Aircraft overflight noise (Marshall Day Acoustics)

WESTERN SYDNEY SECOND AIRPORT DRAFT EIS
OVERFLIGHT NOISE PEER REVIEW
Rp 001 R01 2015417ML | 27 November 2015

Project: **WESTERN SYDNEY SECOND AIRPORT DRAFT EIS PEER REVIEW**

Report No.: **Rp 001 R01 2015417ML**

Figure 1: Comparison of average daily airport movement numbers with other existing Australian International airports

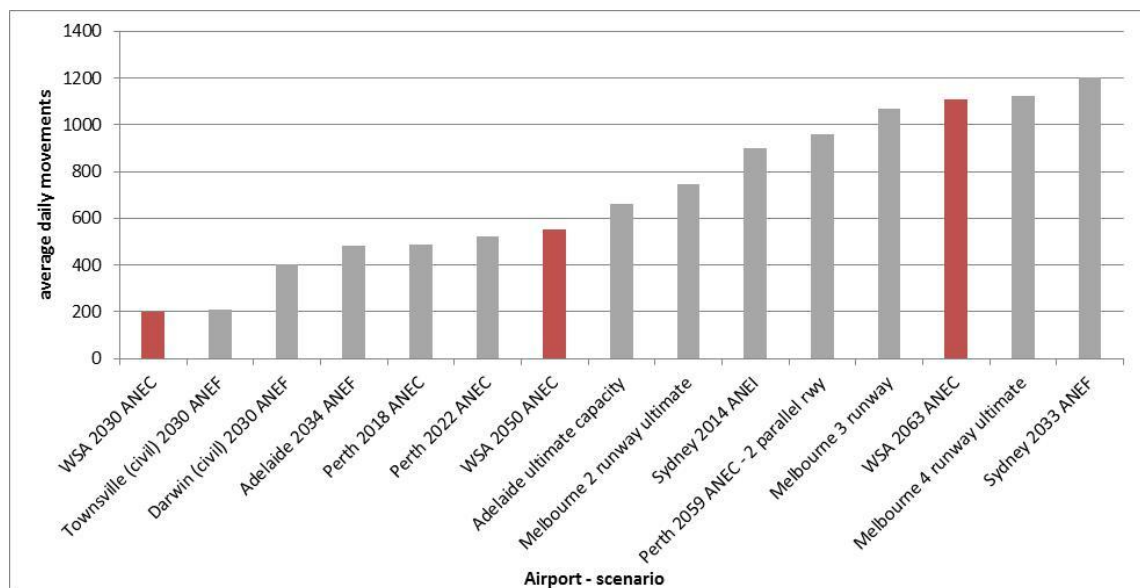
A general review of the movement numbers associated with Stage 1 development has been carried out by comparing the values with current and future movements at other Australian international airports. Figure 1 shows the proposed daily movement numbers for the Stage 1 development appear relatively low compared with other Australian international airports. This may be reasonable given the relatively short time period of 5 years between the commencement of operations and the assessment year. However, this directly translates to a relatively low numbers of aircraft events exceeding relevant noise thresholds when compared to the longer term development plans for the site. Given the objective of the proposal is to develop a major international airport, the relatively low movement numbers raises the question of the suitability of the 5 year time horizon as the appropriate primary assessment scenario for the purpose of obtaining approval for the development, irrespective of the incremental and periodic approvals (under the Airports Act) that would need to occur as part of the ongoing expansion of the airport.

It is noted that the draft EIS refers to ongoing development of airside infrastructure to facilitate the continued growth of the airport. However, it is unclear whether the initial primary infrastructure is to be developed to accommodate a greater number of movements than is projected to occur in Stage 1. Further, it is unclear whether an approval for Stage 1 would specifically restrict the movements to the forecast values presented in the draft EIS. Given these considerations, further information concerning the implications of greater than expected demand under Stage 1 would assist in understanding whether the movement numbers, and therefore the predicted noise levels, could be higher than the forecasts presented in the draft EIS.

Figure 2: Extract from section 3 of the technical report illustrating the influence of mode 23 movements in the Prefer 05 operating scenario

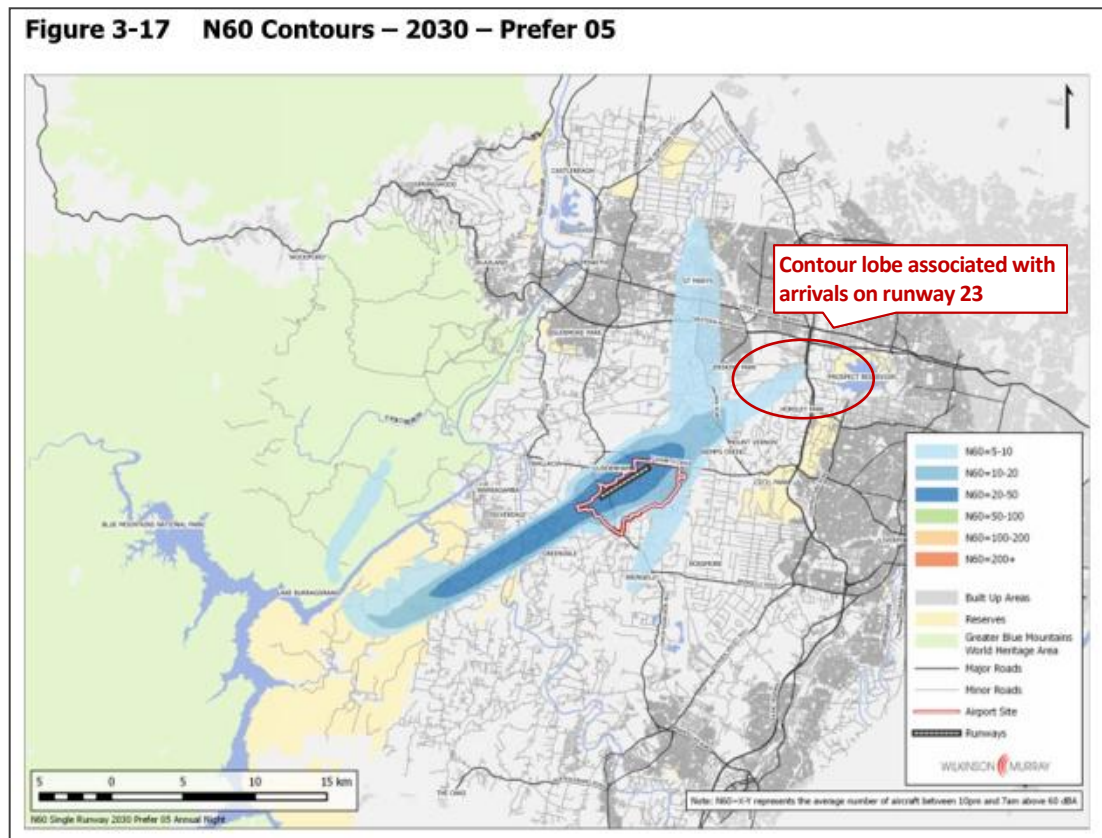
- Noise contour information is presented in terms of ANEC data and NA values for alternative operating configurations including preferred operating strategies such as Prefer 05 (runway strategy favouring movements directed from the southwest and toward the northeast) and Prefer 23 (runway strategy favouring movements directed from the northeast and toward the southwest). It is evident from the noise contours that the Prefer 05 and Prefer 23 scenarios include movements occurring in both directions. For example, this is most evident on figures for scenario Prefer 05. These figures illustrate contour lobes extending to the northeast along the runway centre line, beyond the extent of the departure track, thus indicating the influence of an arrival movement on runway 23 (see example extract in Figure 2 below). Technically this is consistent with the definitions provided for Prefer 05 and Prefer 23. However, these contours may be prone to misinterpretation as single mode contours which illustrate the noise associated with movements occurring in single directions (and would extend further than the illustrated Prefer 05 and Prefer 23 strategy noise contours).

Figure 2-2 – Nearest noise sensitive residential receptors to the Site boundary (marked as light grey points)

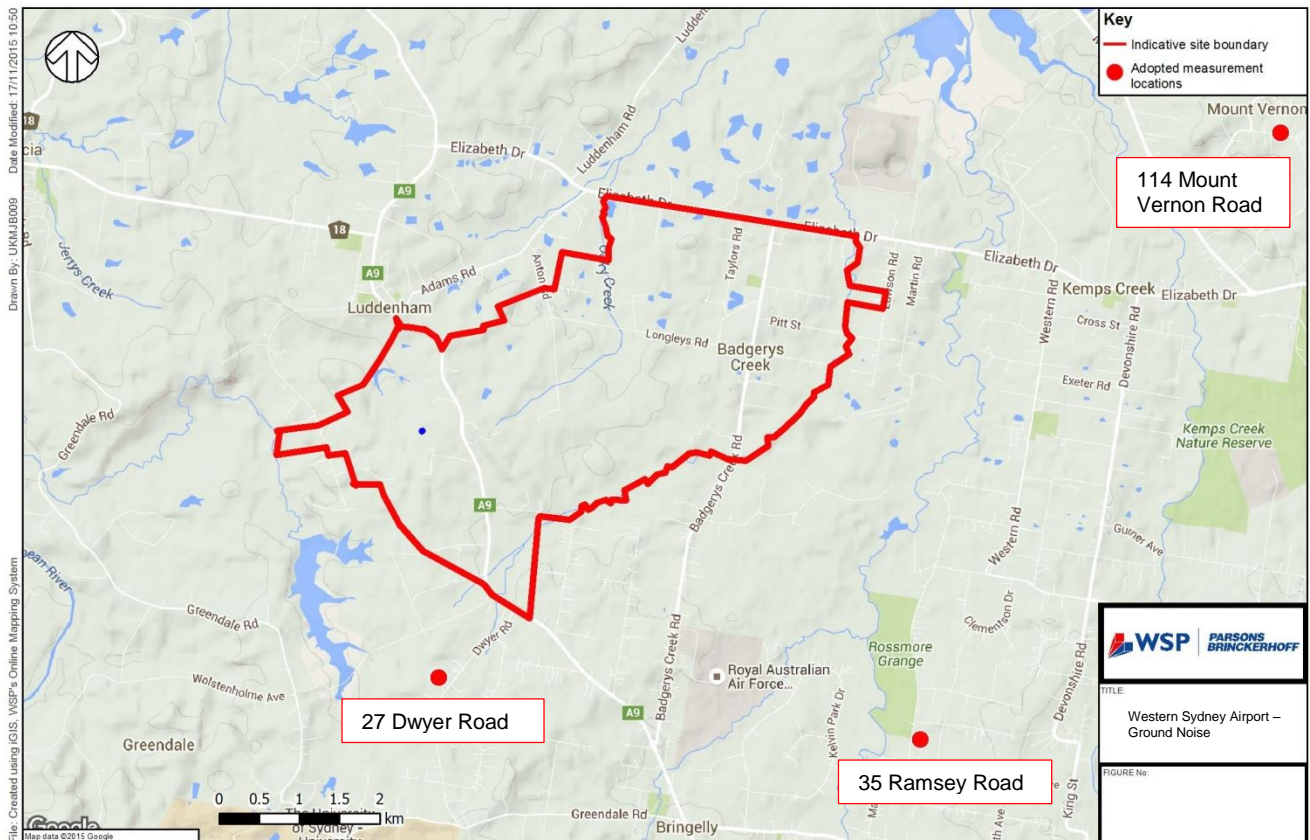
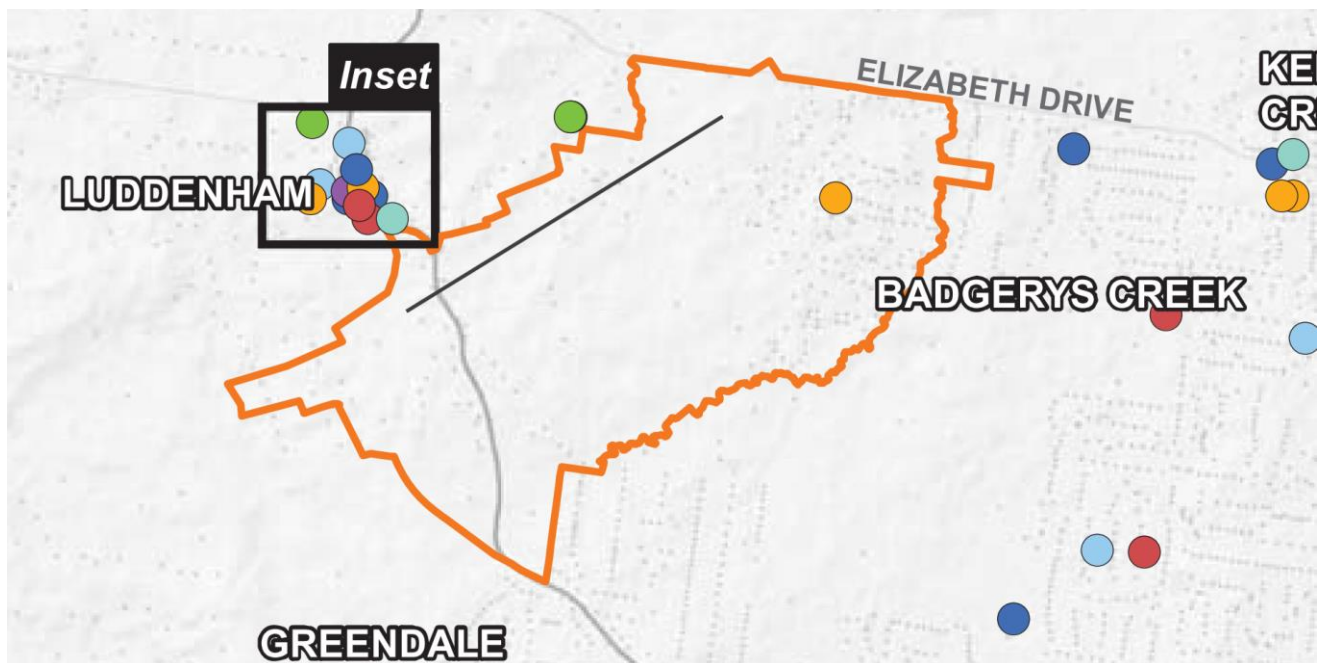
From a review of available aerial mapping, there are closer noise sensitive receptors in the area than those selected for noise monitoring, leaving uncertainty over the noise impacts on the most affected noise sensitive receptors, particularly for properties in Luddenham to the north west of the Site. Figure 2-1 shows the adopted noise monitoring locations that are closest to the Site boundary. Figure 2-2 shows that there are many noise sensitive receptors much nearer to the Site boundary (marked in grey). Further consideration should therefore be given to quantifying the existing noise environment for properties closest to the airport.

There is insufficient detail provided to accurately determine the specific noise monitoring locations, whether noise measurements were taken in free-field conditions, or at what height above ground microphones were positioned at. It is not possible to determine whether microphones had direct line of sight to dominant noise

sources such as main roads, or whether they were placed in backyards. There is a risk that existing noise levels have been overestimated if they have not been placed on quietest facades of residential receptors. The existing noise levels have been used to determine assessment criteria, so this information could potentially affect the conclusions of the assessment. Therefore the precise measurement locations should be defined.

Figure 2-3 - Sensitive receivers surrounding the airport site (reproduced from Western Sydney Airport draft EIS)

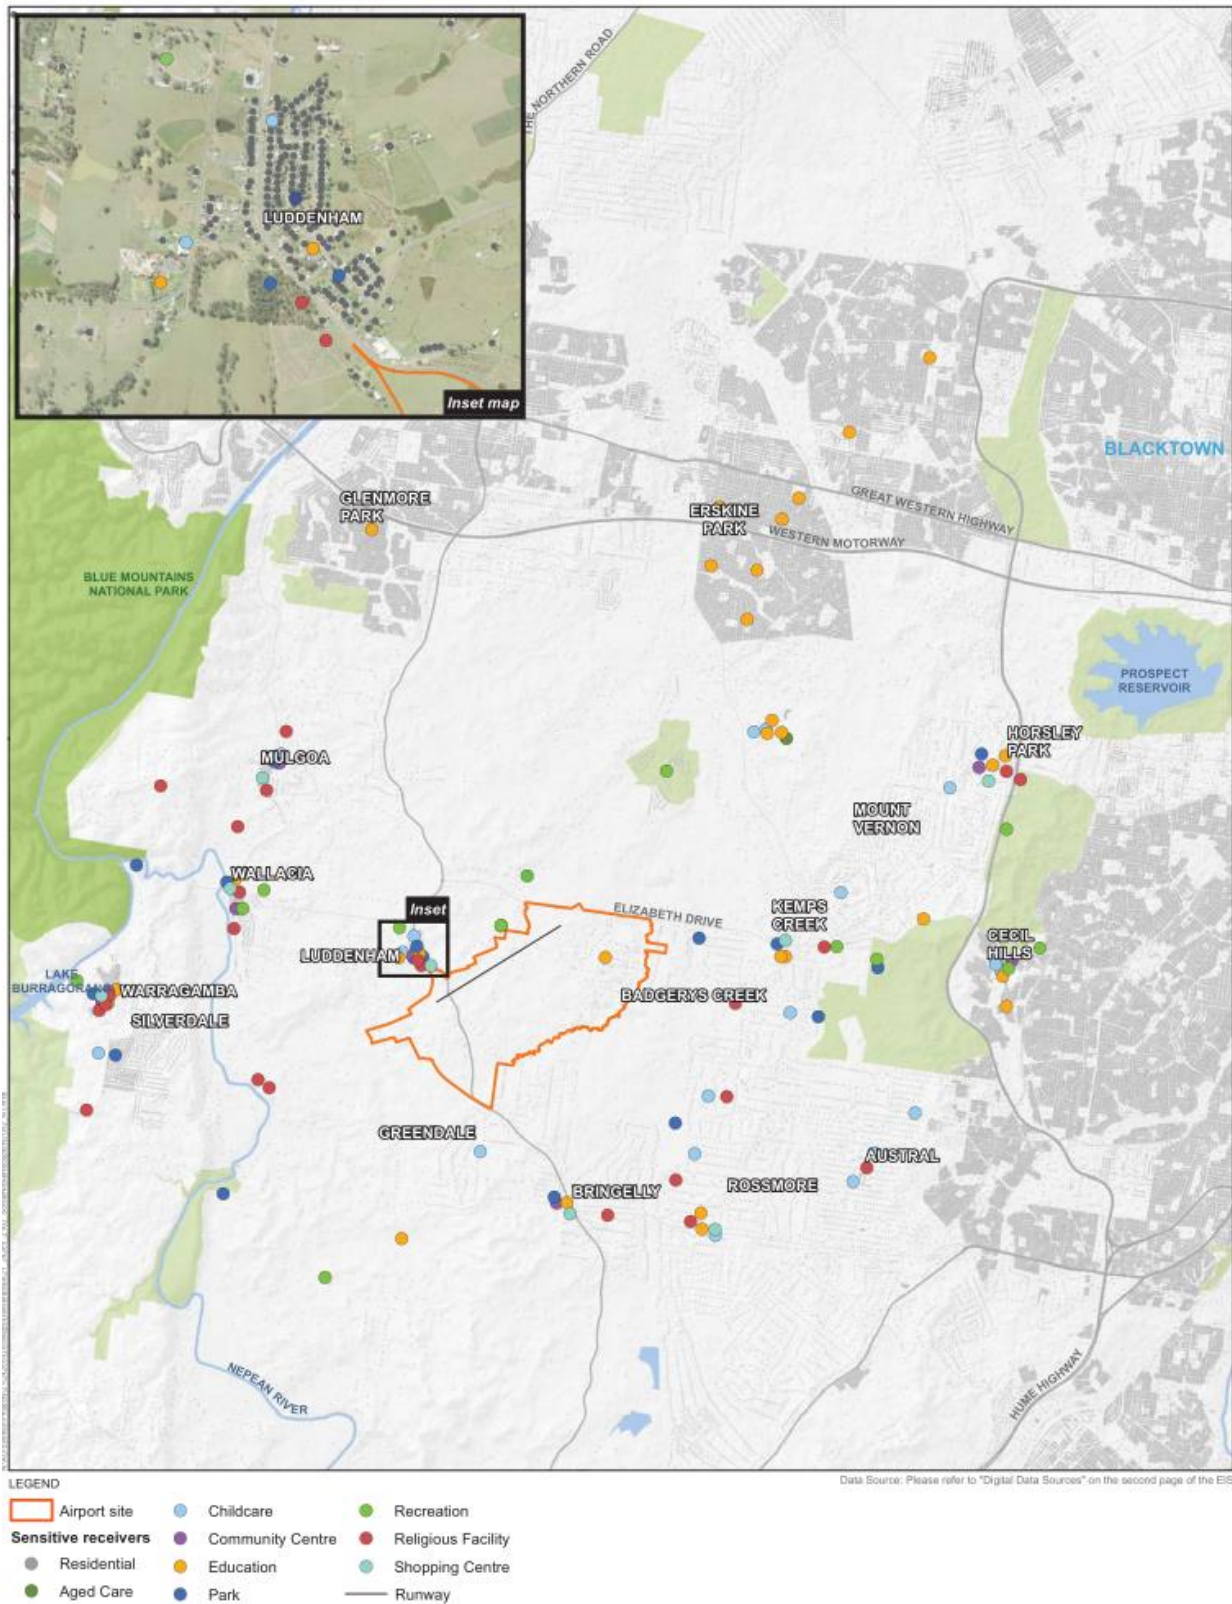
Figure 11-2 (reproduced below in Figure 2-3) depicts the noise sensitive receptors surrounding the airport site. It identifies the location of nearby non-residential noise sensitive receptors in the area clearly, however the location of residential receptors is indicated by very small points in light grey, which are difficult to observe and could be considered misleading. It is recommended that Figure 11-2 is updated to show more clearly the location of residential receptors.

Section / Paragraph Reference	Text Reference / Figure Description	Comment	Recommendation	Significance of Issue
11.3, Figure 11-2, p79	A figure depicting noise sensitive receptors surrounding the airport site	<p>It is difficult to see the location of nearest residential receptors, as their location appears to be indicated by very small points in light grey – whereas the other types of receptor are more clearly marked.</p> <p>It is also difficult to see this in the inset image displaying Luddenham.</p> <p>The initial impression that the figure currently gives is that there are little, if any.</p>	Recommend that the figure is updated to show more clearly the location of residential receptors, particularly in Luddenham.	Noted for information.

Figure 2-4 - Ground based operational noise source locations, 2030 (reproduced from EIS Appendix E2 Figure 3-1)

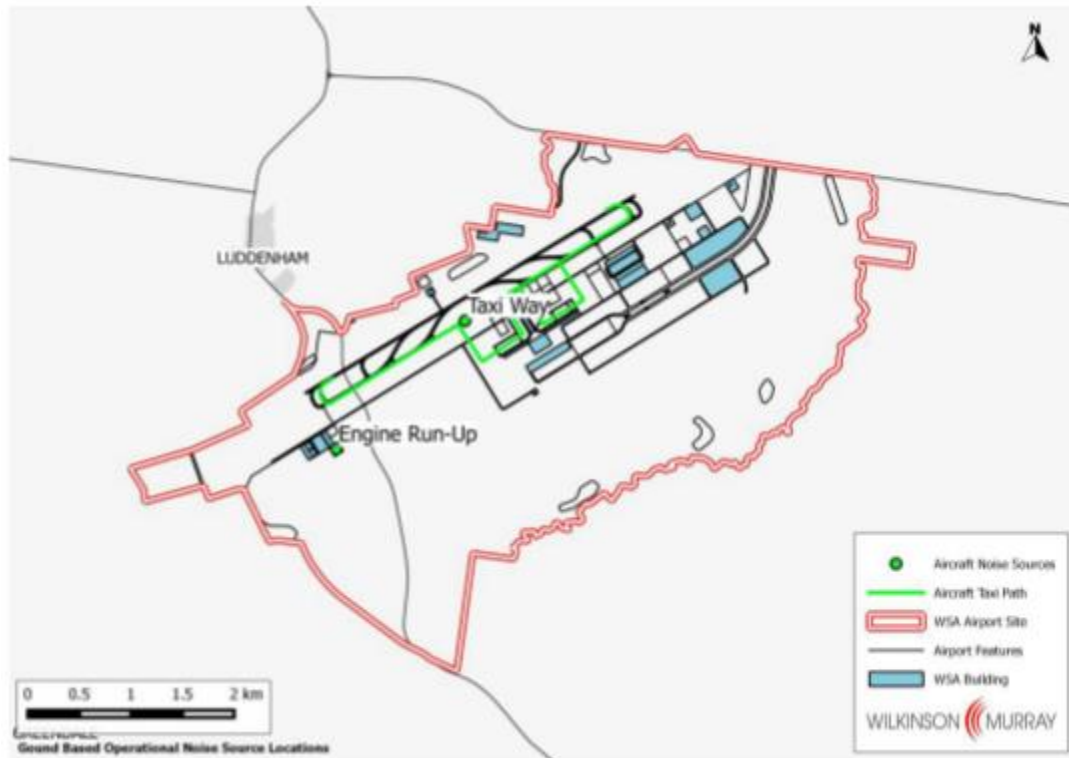
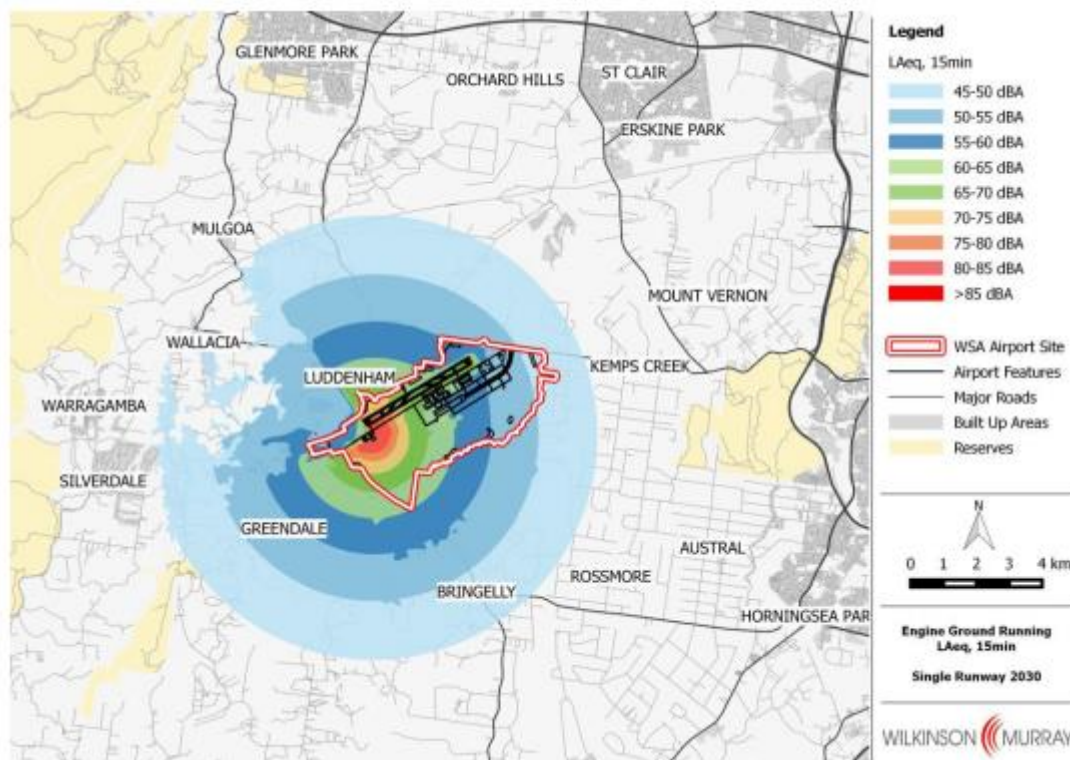
It has been assumed that there will only be one high power run up, which would occur for less than 5 minutes in any night. INP Section 4.2 states that the acceptable noise level may be increased by 5 dB to account for unusual and one-off events, but does not apply to regular high-noise levels that occur more frequently than once per day. Should there be more than one high power run-up in one night, it would be inappropriate to apply this correction. Clarification is required to determine the likelihood of high power ground run-ups in a given night-time period.

The assumed location for ground run-ups is defined in Figure 3-1 of Appendix E2 (presented in Figure 2-4 below), however the indicative building location near the location is not finalised nor is fixed within the application. Figure 3-2 of Appendix E2 (presented in Figure 2-5 below) shows that communities to the west and north west of the Site benefit from the screening afforded by this building. Noise impacts could significantly change if the buildings or run-up area change location. It is therefore considered appropriate to assess a scenario where the building does not provide any acoustic benefit, to take into account that final locations are not fixed and may change.

Section / Paragraph Reference	Text Reference / Figure Description	Comment	Recommendation	Significance of Issue
3.5.1 / p13, para 2, Figure 3-1, Figure 3-2	<i>"It has been assumed that aircraft ground runs would occur at the location shown in Figure 3-1."</i>	<p>It is acknowledged that the assumed location for run-ups is defined in Figure 3-1, however there is a concern that, at this stage, the indicative building location near the position is not finalised nor is fixed within the planning application.</p> <p>It is evident from Figure 3-2 that communities to the west and north west of the Site benefit from the screening afforded by this building.</p> <p>Should the building or run-up area move, it is likely that it could significantly affect the resulting noise impact from the Site.</p>	Given the indicative layout, and the level of assumed acoustic benefit provided, it is considered appropriate to assess a scenario where the building does not provide any acoustic benefit, to take into account that final locations are not fixed and may change.	High
